PROJECT NUMBER: PR-2024-010074

Application Number: SI-2024-01533

Illustrative Landscape + Layout Plan

**Cottonwood Apartments
GSL**
Old Airport Avenue
Albuquerque, New Mexico

Illustrative Landscape
& Building Layout Plan

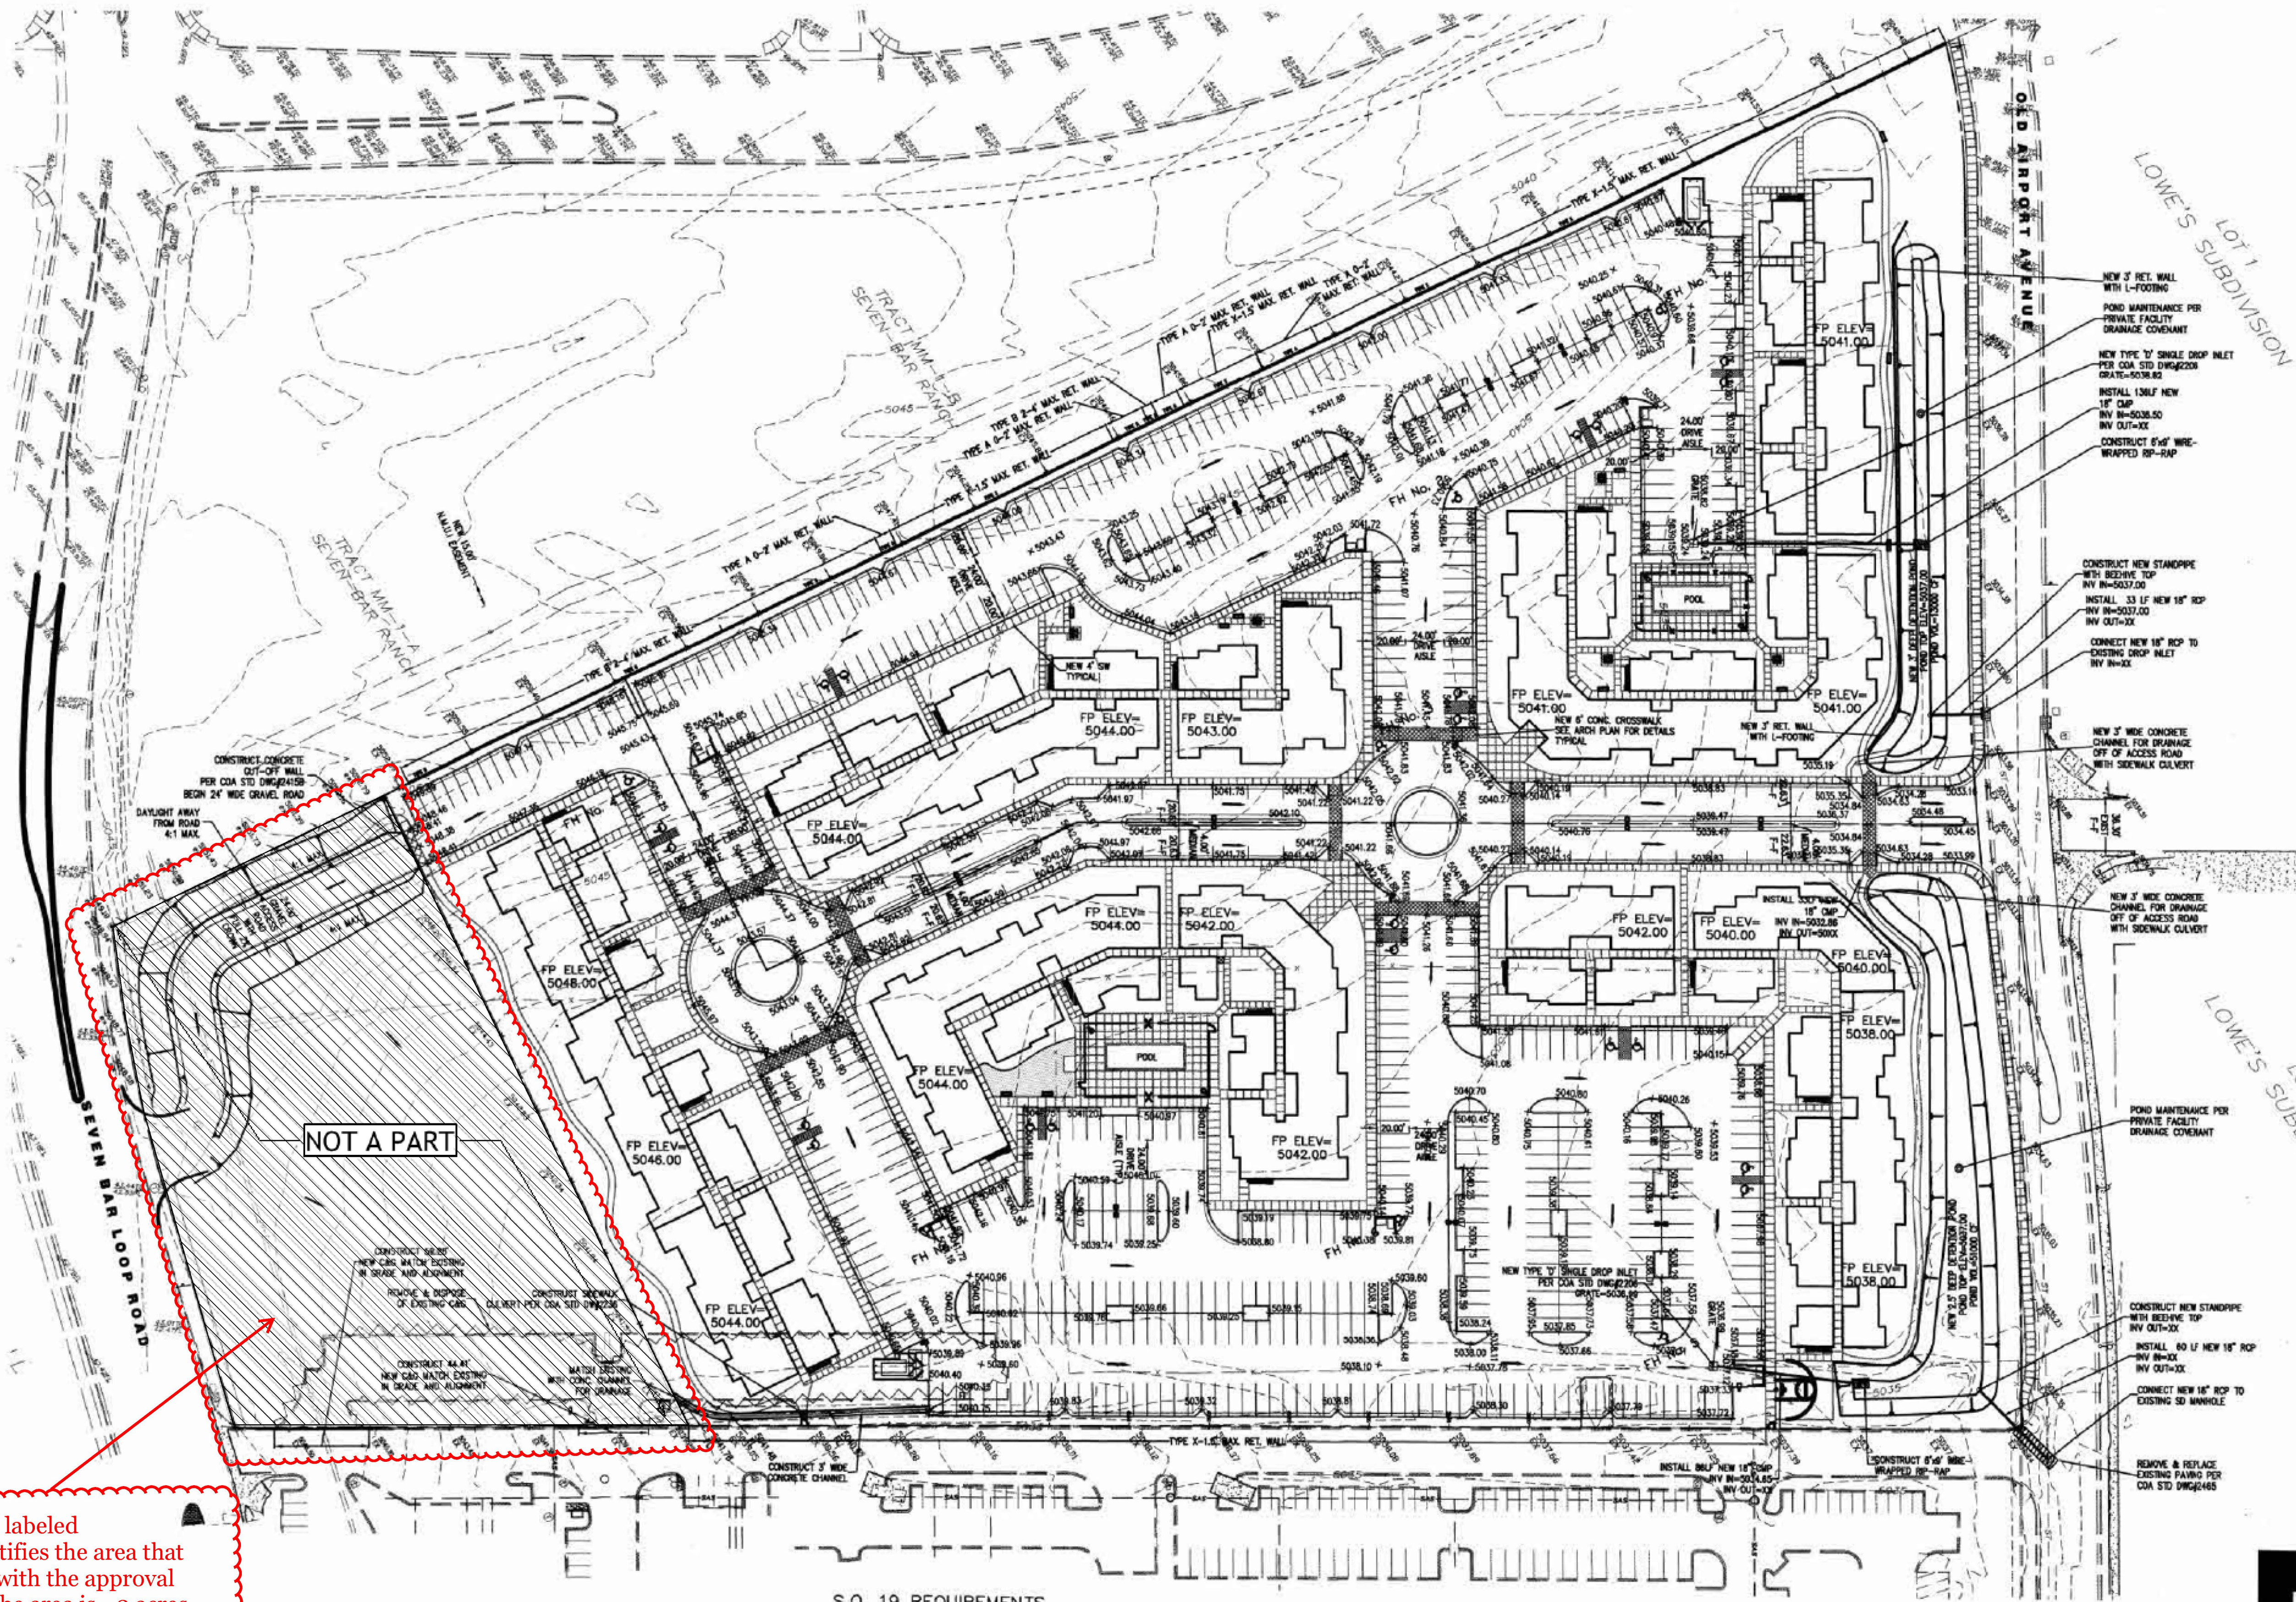
The dashed lines labeled "Not Apart" identifies the area that will be removed with the approval of this request. The area is ~2 acres

CONCEPTUAL UTILITY PLAN 6

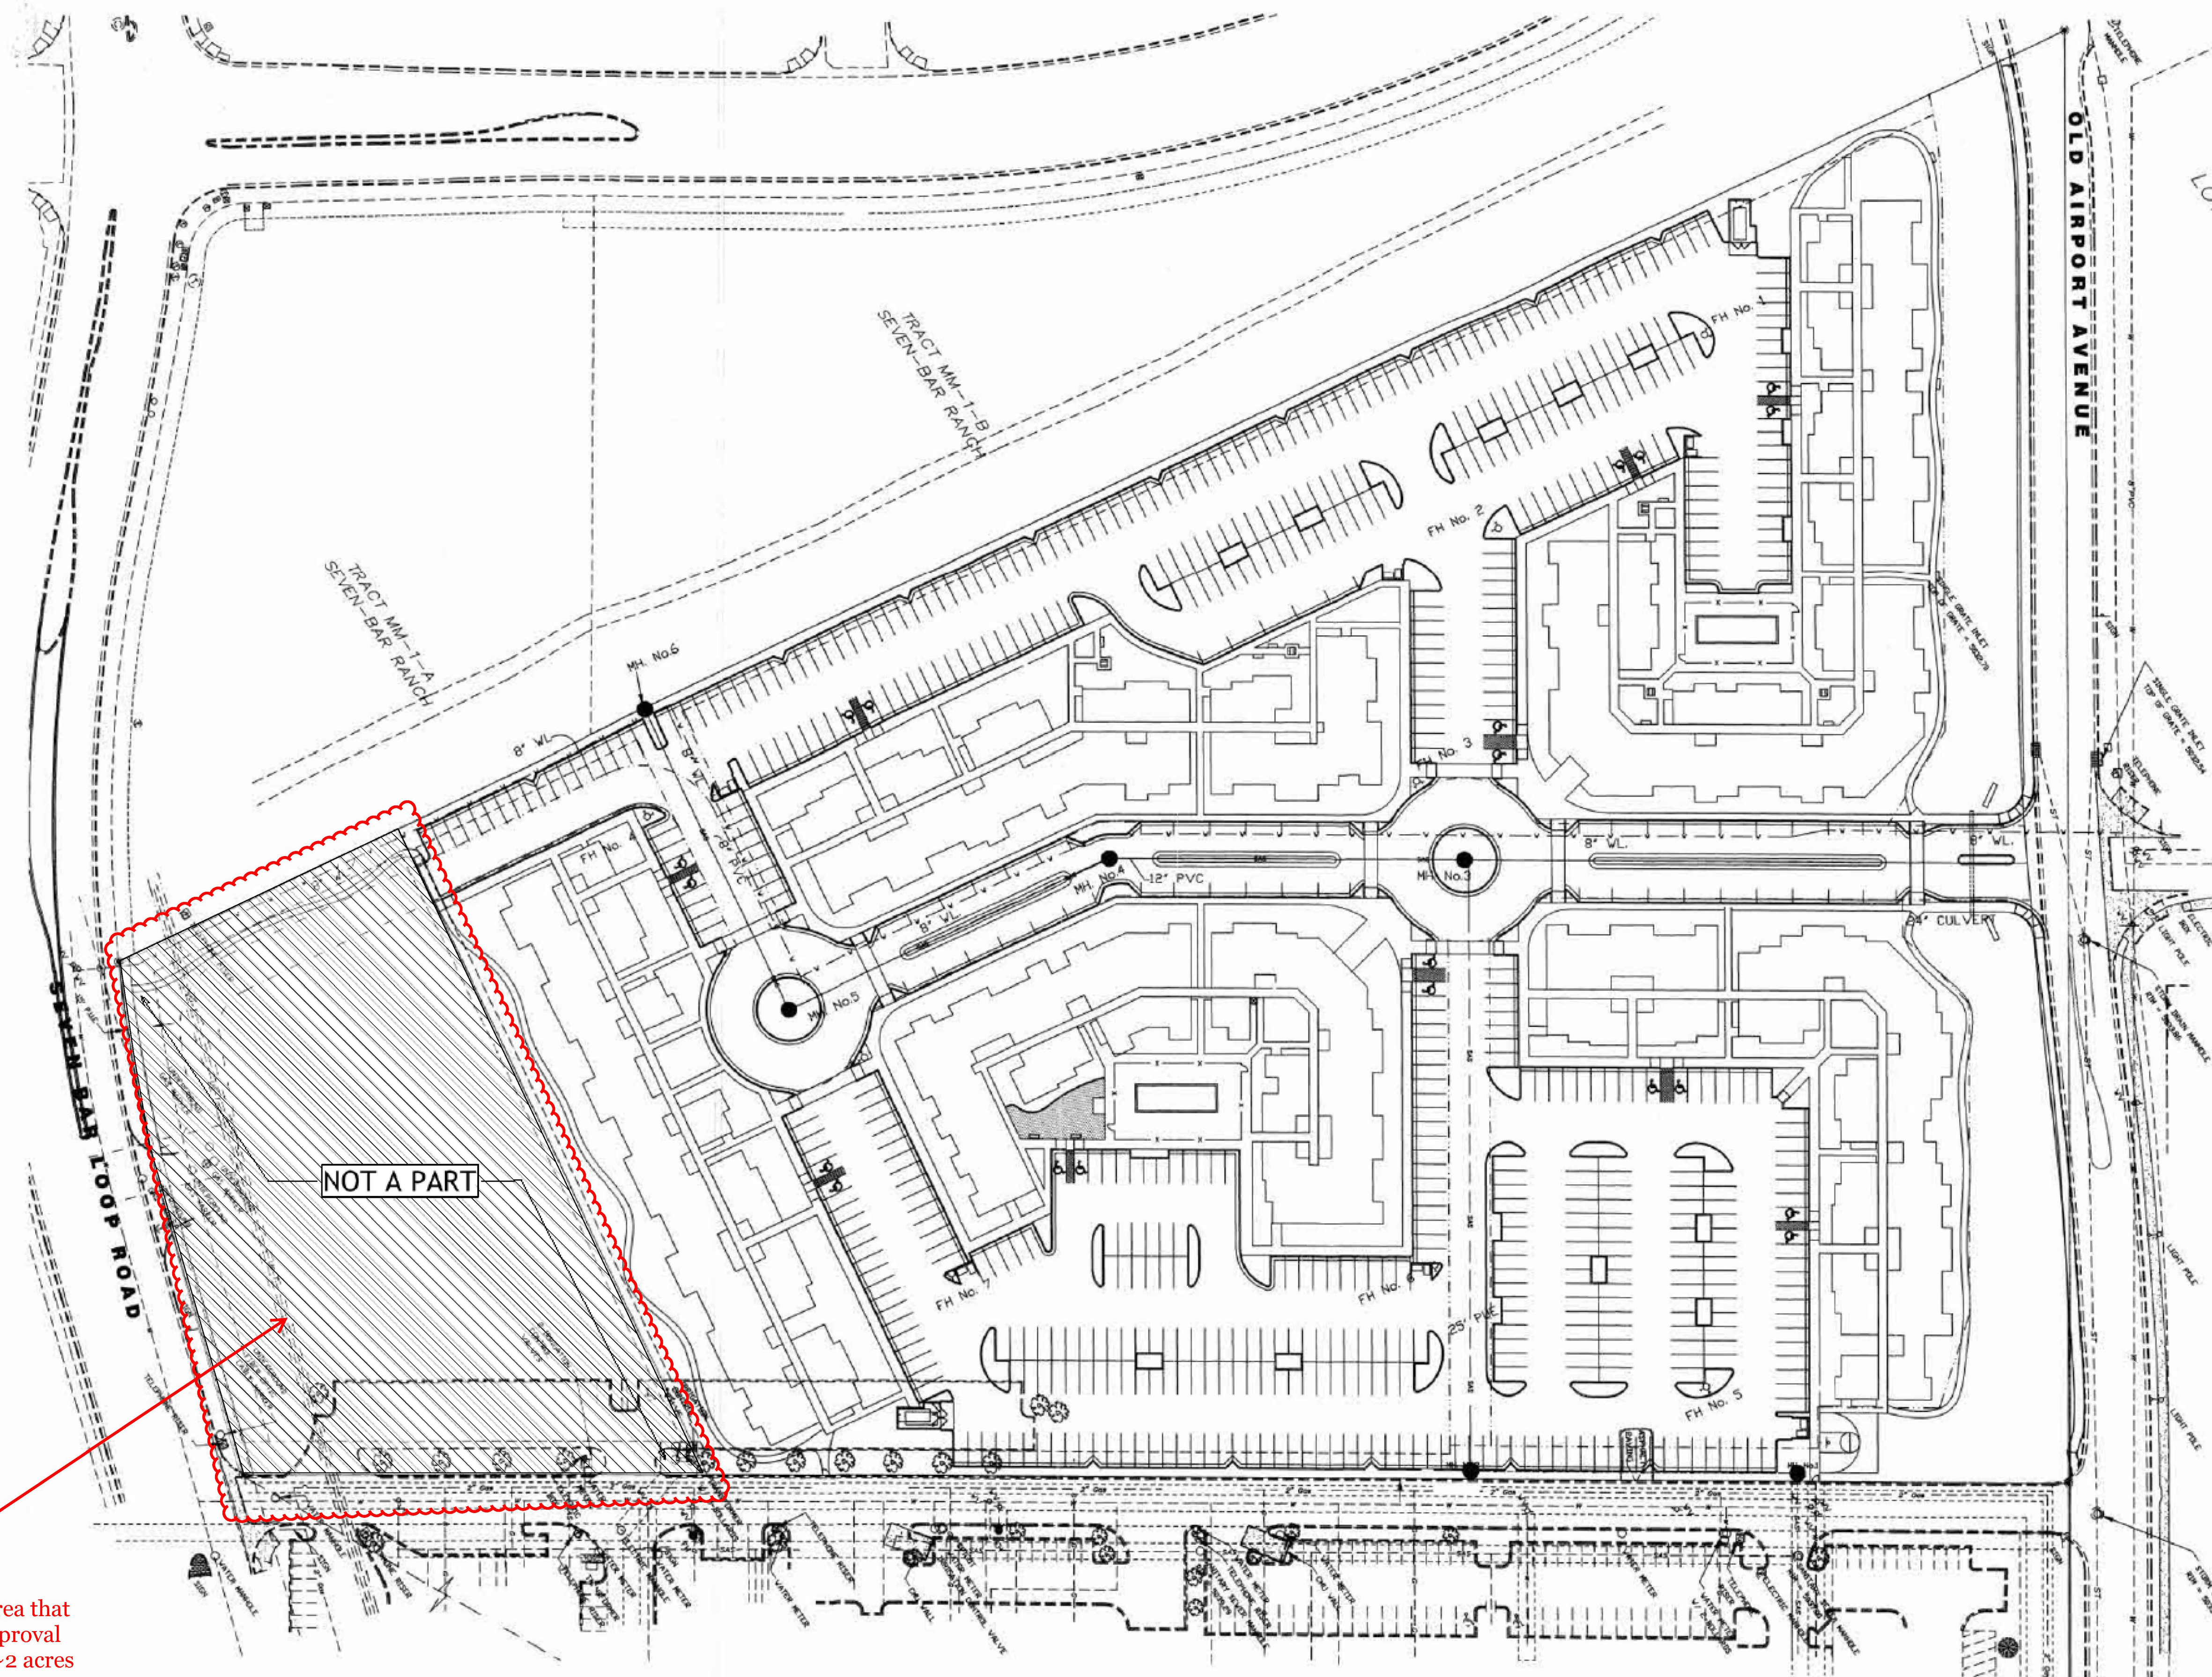
The dashed lines labeled "Not Apart" identifies the area that will be removed with the approval of this request. The area is ~2 acres

Traffic Circulation Plan

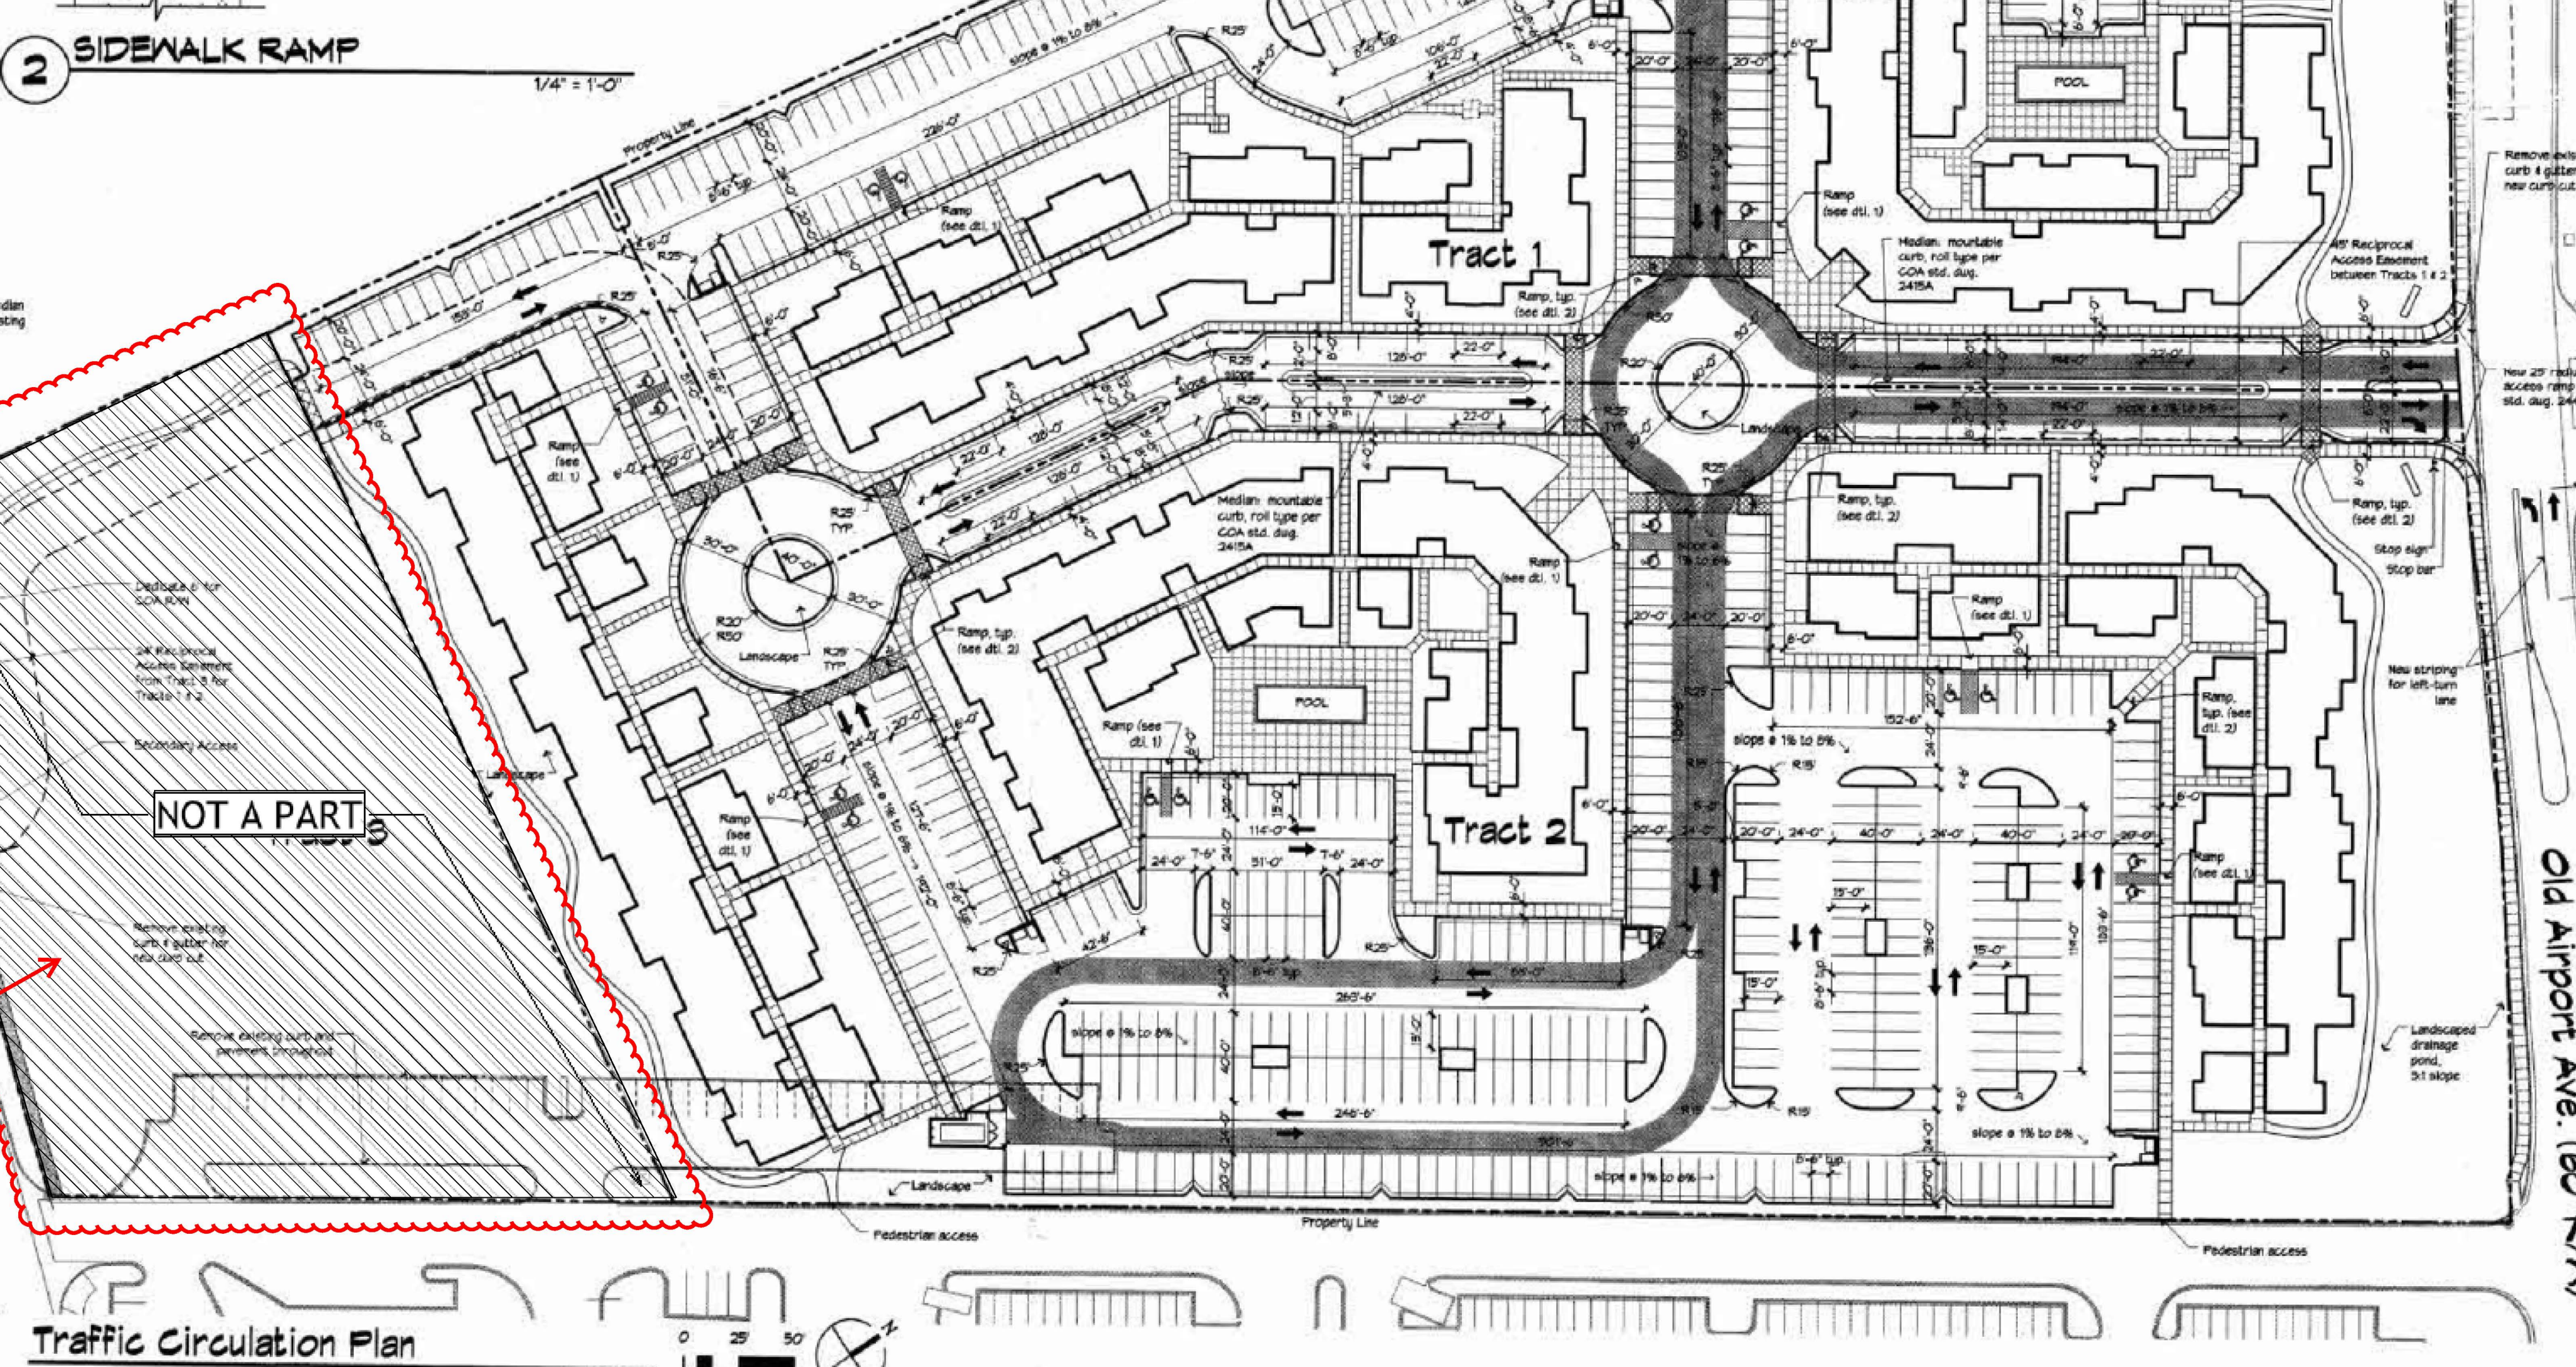
The dashed lines labeled "Not a Part" identifies the area that will be removed with the approval of this request. The area is ~2 acres
